# Wisconsin Department of Transportation

**Proposal #19: 1550-02-76, WISC 2022518**  
**Baldwin – Cumberland;**  
**St Croix/Polk Co Ln To Cth J**  
**USH 63**  
**Polk County**

### Letting of September 13, 2022

This is Addendum No. 01, which provides for the following:

Addendum No. 01  
ID 1560-02-76  
Revised Sheet 10  
September 8, 2022

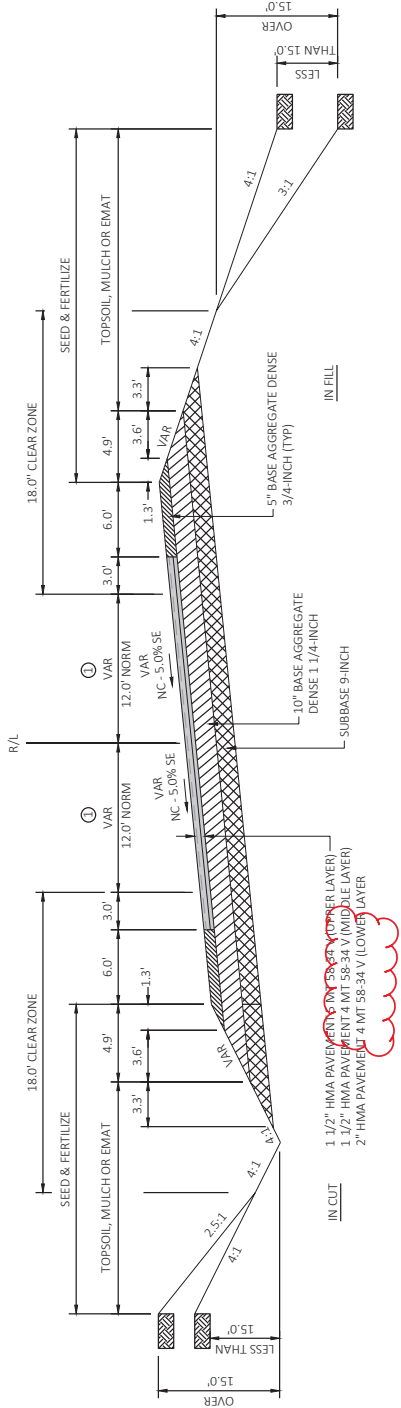
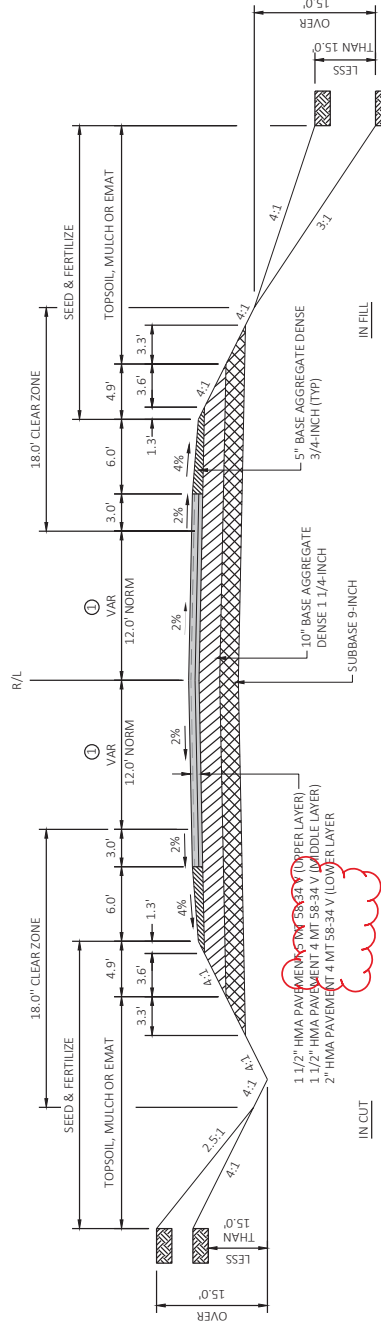
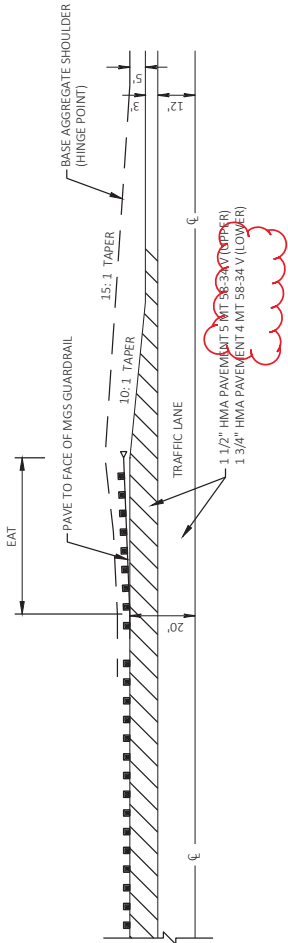
<b>Revised Plan Sheets – ID 1550-02-76</b>	
Plan Sheet	Plan Sheet Title (brief description of changes to sheet)
2	General Notes – PWL table
8-12	Typical Sections – Change Lower/Middle HMA Layers to 4 MT 58-34V
13-14	Details - Change Lower/Middle HMA Layers to 4 MT 58-34V
28, 30	MQs – Change Common Excavation and MA Summary Table MQs

Addendum No. 01  
ID 1550-04-76  
Revised Sheet 3  
September 8, 2022

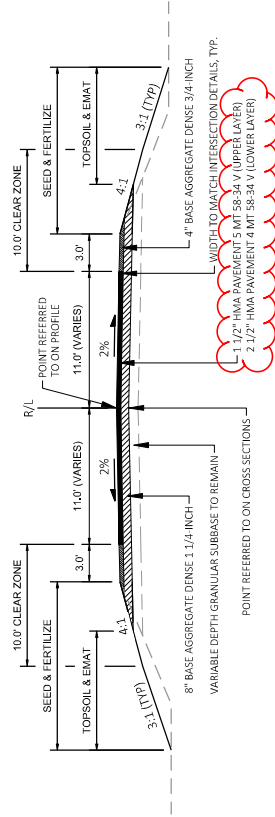
<b>Revised Plan Sheets – ID 1550-04-76</b>	
Plan Sheet	Plan Sheet Title (brief description of changes to sheet)
3-4	Typical Sections – Change Lower HMA Layers to 4 MT 58-34V
12	MQs – Change HMA Summary Table MQs
